STATE OF MAINE
DEPARTMENT OF TRANSPORTATION
16 STATE HOUSE STATION
AUGUSTA, MAINE 04333-0016

January 11, 2019
Subject: Piscataqua River Bridge Wearing
Surface Replacement
State WIN: 019270.00
Location: **Kittery & Portsmouth, N.H.**
Amendment No. 5

SHEET NUMBER
11B
OF 232

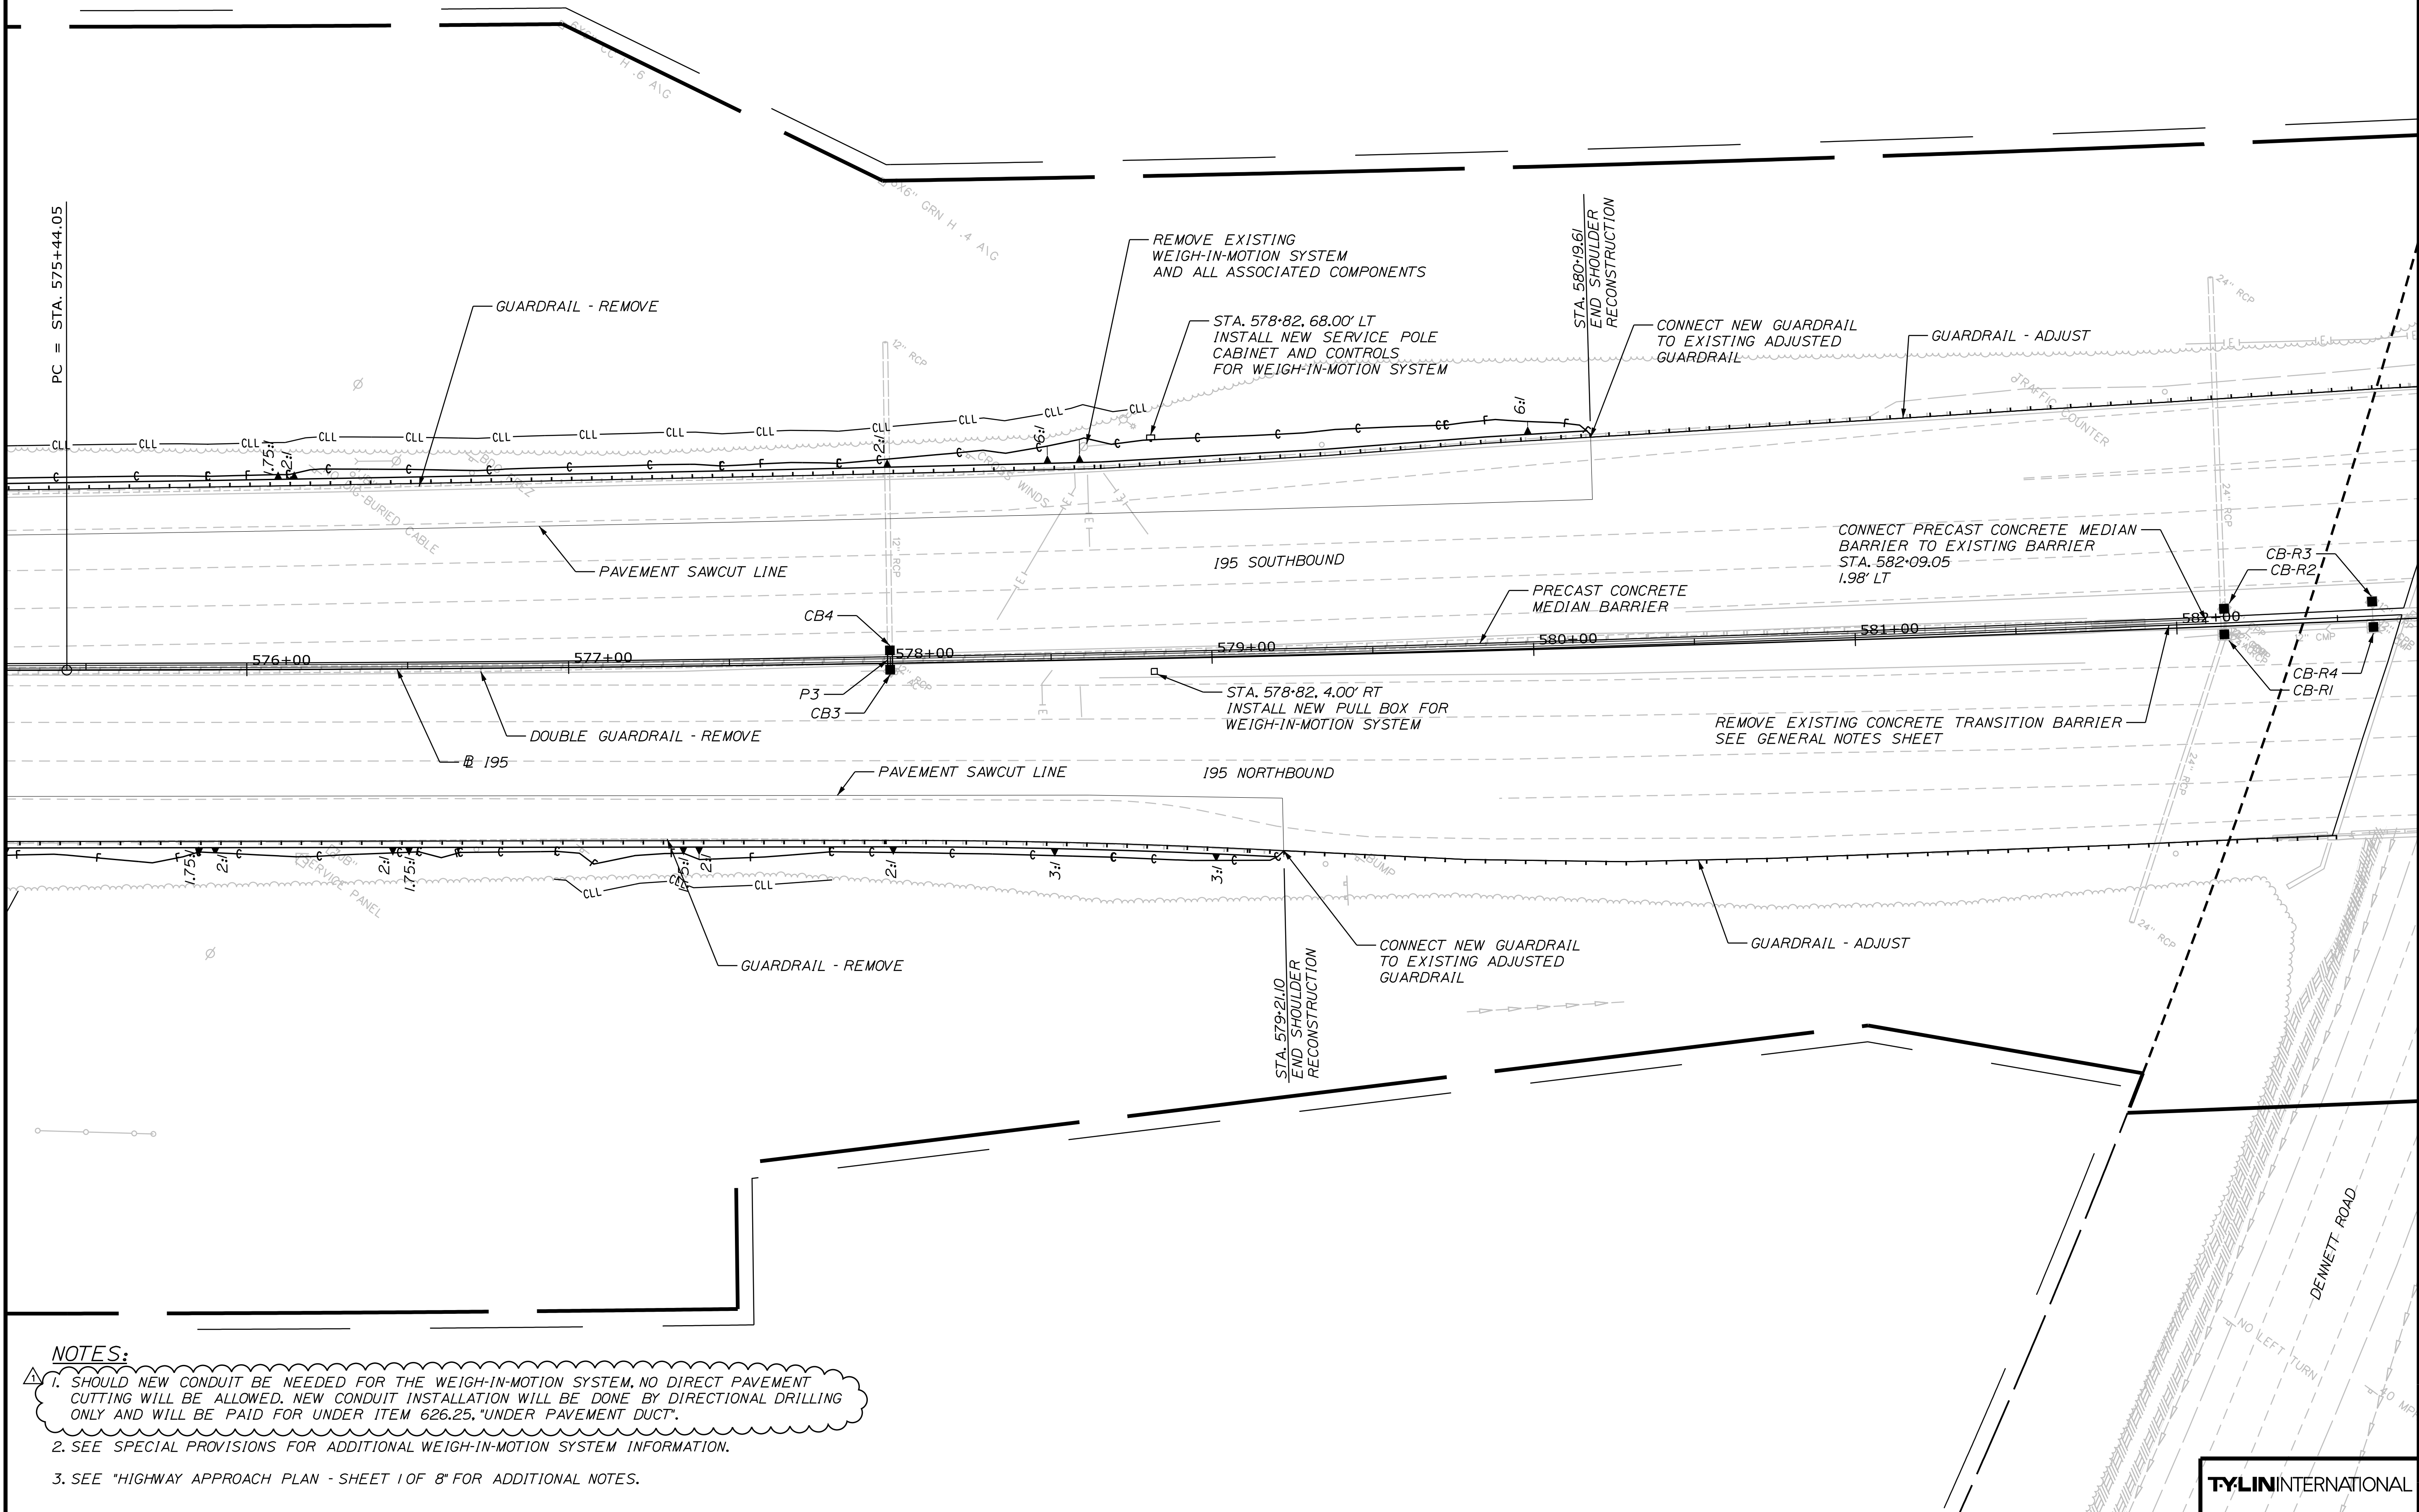
Question: Per Amendment #3, Sheet 13 note references directional drilling would be incidental. The Amendment stated it was acceptable to change this to a pay item. Will this be done in a future Amendment?

Response: Please see the revised sheets and specs issued with this Amendment.

1. SHOULD NEW CONDUIT BE NEEDED FOR THE WEIGH-IN-MOTION SYSTEM, NO DIRECT PAVEMENT CUTTING WILL BE ALLOWED. NEW CONDUIT INSTALLATION WILL BE DONE BY DIRECTIONAL DRILLING ONLY AND WILL BE PAID FOR UNDER ITEM 626.25, "UNDER PAVEMENT DUCT".
2. SEE SPECIAL PROVISIONS FOR ADDITIONAL WEIGH-IN-MOTION SYSTEM INFORMATION.
3. SEE "HIGHWAY APPROACH PLAN - SHEET 1 OF 8" FOR ADDITIONAL NOTES.
